From: [Garza, Johnnie](#)
To: [Pat Womack](#); [Misti Schulz](#)
Cc: [Lissak, Matt](#); [Adam Boatright](#); [Kamie Fitzgerald](#)
Subject: RE: Taylor - Williamson County Transportation Plan
Date: Wednesday, July 22, 2026 12:09:56 PM
Attachments: [image002.png](#)
[image003.png](#)
[image004.png](#)
[20260722 - Project Mustang Williamson County Road Exhibit.pdf](#)

Subject: RE: Taylor - Williamson County Transportation Plan

Thank you for taking my phone call. Attached is a markup showing the property we're developing in Taylor, TX, overlaid on the Williamson County LRTP Amended Mapbook.

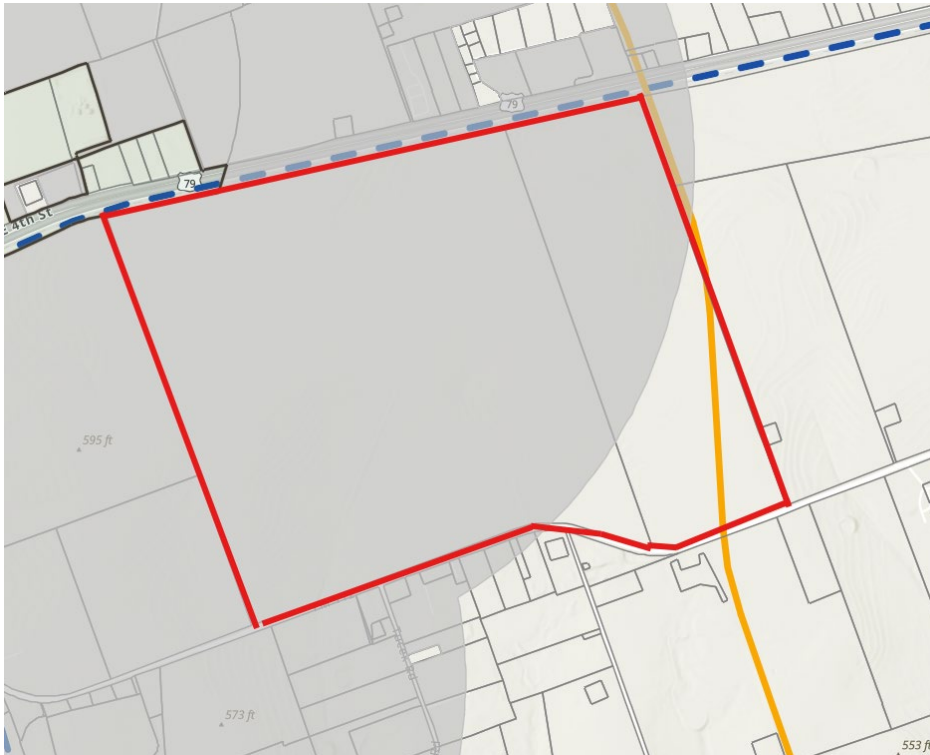
1. Is the LRTP Amended Mapbook the current transportation planning document for Williamson County? I assume it is since it is an amendment, but I wanted to confirm. The City of Taylor GIS map does not appear to align with the amended mapbook, and I want to make sure we're coordinating with the correct planning documents before submitting to the City this Friday.

2.

proposing and dedicating a roadway along the west side of the property (pink line shown on the exhibit), we're hoping to understand whether there is any opportunity to align both thoroughfare plans.

Wilco LRTP Amended Mapbook

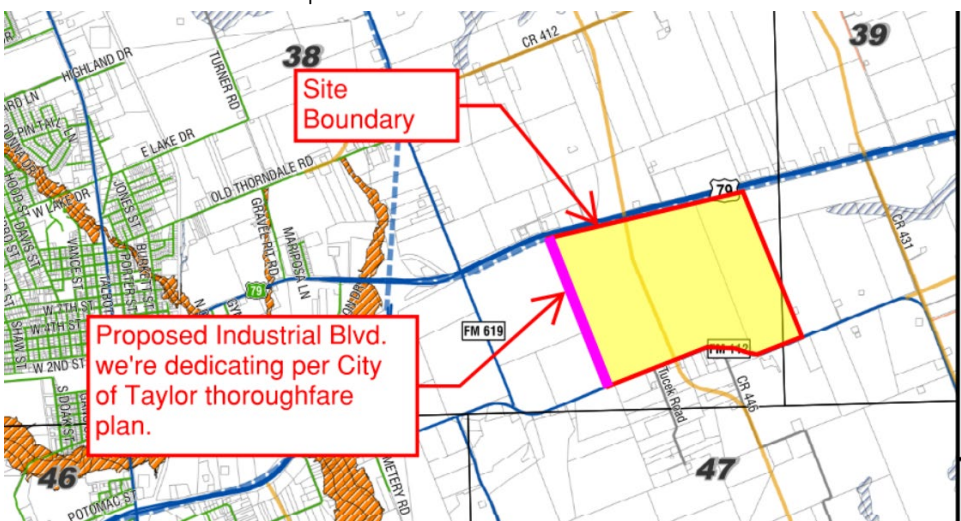
Is there any flexibility within the LRTP regarding roadway alignments? Since we're already
